Title:               Advisory Committee on Reactor Safeguards  
                          Metallurgy and Reactor Fuels Subcommittee  
                          Afternoon Session

The purpose of this meeting is to receive a briefing on NUREG-2195, Consequential Steam Generator 2 rupture analysis for Westinghouse and Combustion Engineering plants with thermally treated alloy 600 and 690 steam generator tubes. We'll hold presentations from representatives from the Office of Nuclear Regulatory Research.

Consequential Steam Generator Tube Rupture (C-SGTR) Subcommittee Briefing  
December 15, 2016

## Thermal Hydraulic Analysis and Responses to ACRS and Public comments

# CE SGTR Behavior Differs from Westinghouse Plants

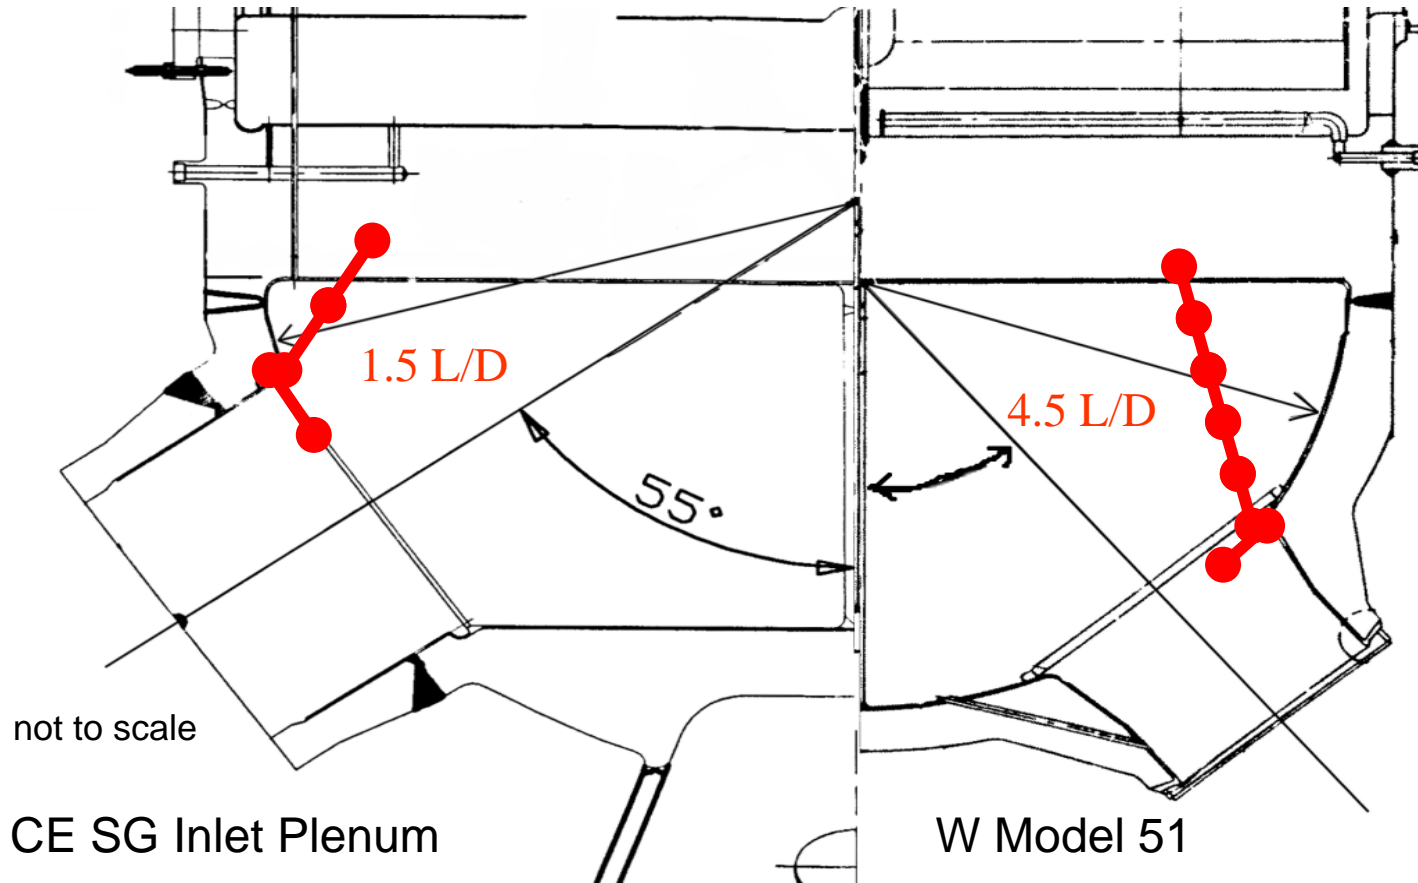
19 CHAIR REMPE: So, Mike, your Slide 20 says  
20 some CE plants have shallower inlet plenum. Do you  
21 have any feel --

- Less mixing of hot gases before reaching SG tube inlets
  - Lower hot leg Length/Diameter ratio
  - Some CE plants have shallower inlet plena
- In CE SG tubes are exposed to similar gas temperatures as hot legs
- Under certain conditions unflawed tubes could rupture before hot legs
- Unlike for the rupture of a flawed tube, multiple unflawed tubes could potentially reach the failure condition nearly simultaneously resulting in a rupture large enough to depressurize the RCS sufficiently fast to prevent failure of other RCS components.

# Impact of changing codes (1/2)

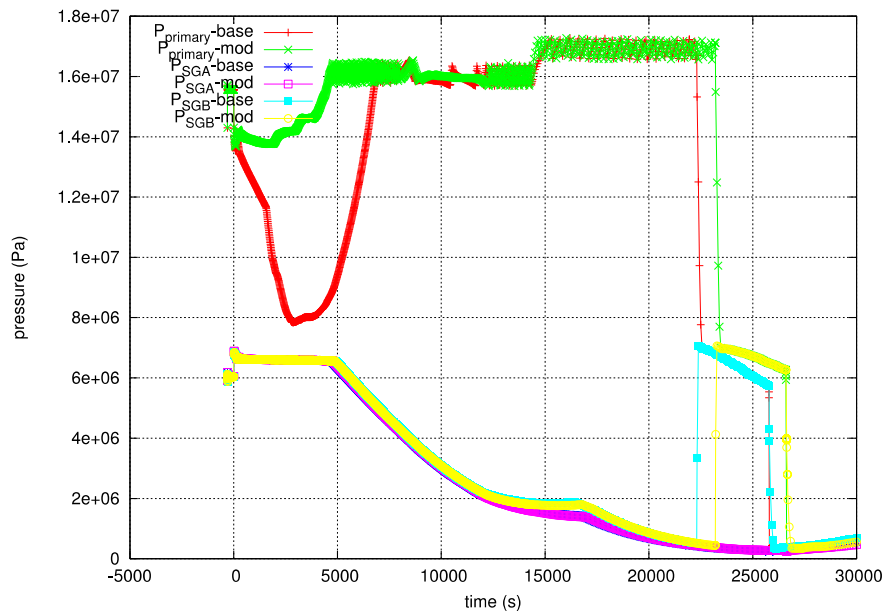
- Both ACRS and public provided comments regarding the impact of changing codes
- Code to use was a major choice at beginning of project
  - RELAP/SCDAP
    - Used for Steam Generator Action Plan (SGAP) work
      - Easy to directly compare results
    - Hot tube modeling and application of CFD already developed
  - MELCOR
    - NRC Severe Accident code
    - Calculate transport and release of fission products

Effect on system pressures

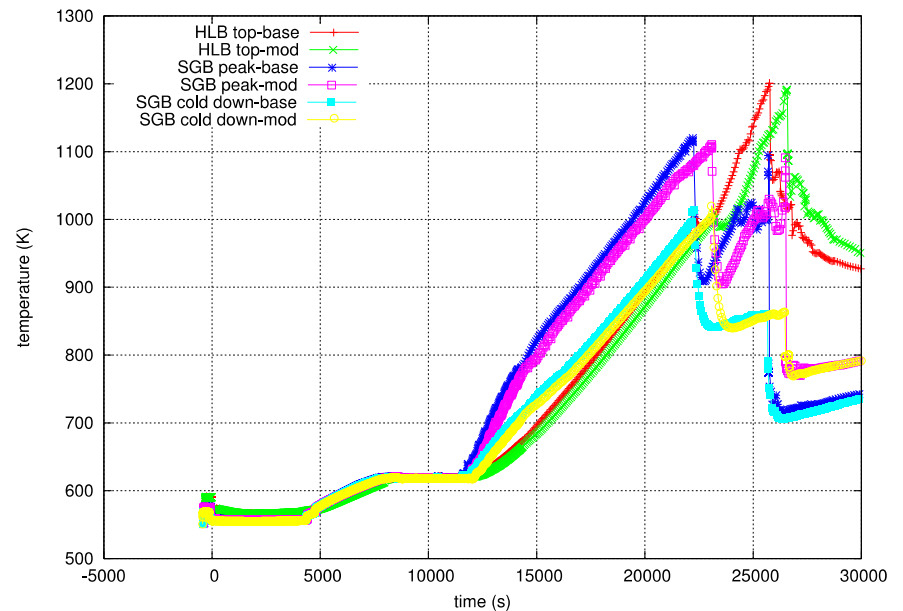
20 DR. SALAY: And we had a public comment on  
21 reactor coolant pump seal leakage for the CE analysis.  
22 We used 21 gpm to be consistent with the steam general  
23 action plan.

24 It was pointed out that this may not be  
25 correct, you might have a substantially less leakage

1 for CE. In the comment, they included a calculation  
2 which showed a less of a pressure drop. And I'll show  
3 a figure.

4 And so we ran the base case disabling  
5 reactor coolant pump seal leakage. We got a similar  
6 pressure drop to what the public comment calculation  
7 had.

1 Seamed to be quite close to what the comment calculation  
2 was. And so this was a good catch.

3 Yes, so now we have results that show kind  
4 of bound leakage, seal leakage, between zero and 21.  
5 And the amount it impacted, it's failure was a few  
6 minutes. And this is where tube fails and hot leg  
7 fails.

Fig. 8: stsbo decay and oxidation power contribution

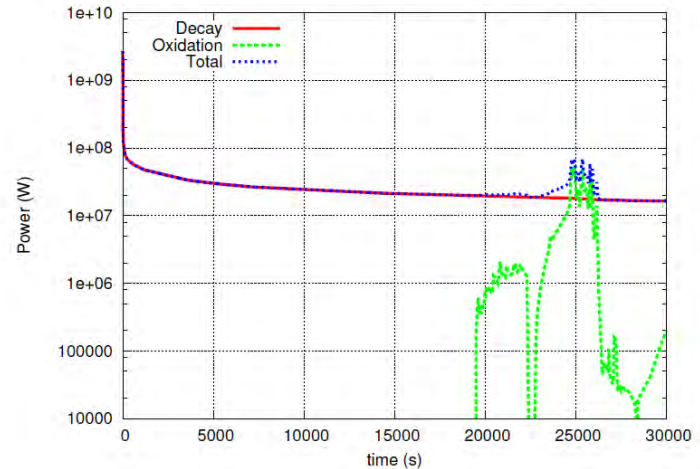
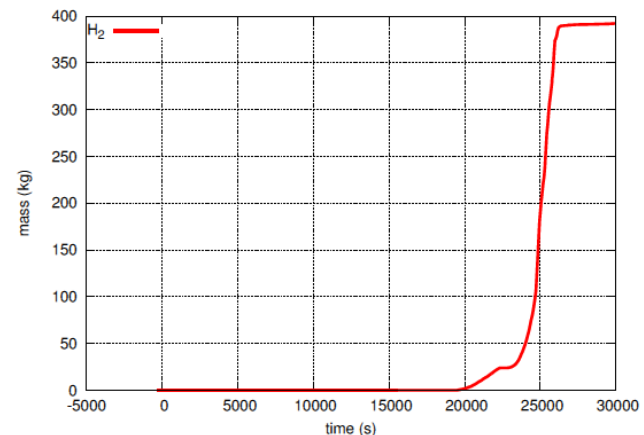
- Relative decay and oxidation powers
  - Comments regarding hydrogen behavior and relative decay and oxidation powers
  - Hydrogen generated when it appeared, not predicted to be held up in system
  - Significant oxidation power only during hydrogen generation
- Oxidation of steel
  - Steel oxidation in RCS components typically not modeled in severe accident analyses
    - MELCOR models steel oxidation in core
    - CSGTR analyses did not consider steel oxidation
    - Reviewed reaction rates
      - Steel oxidation in RCS does not appear to be a major effect

21           Our analysis didn't consider it, but since  
22          the question arose we went and looked at the reaction  
23          rates. And it doesn't seem to be a major effect.
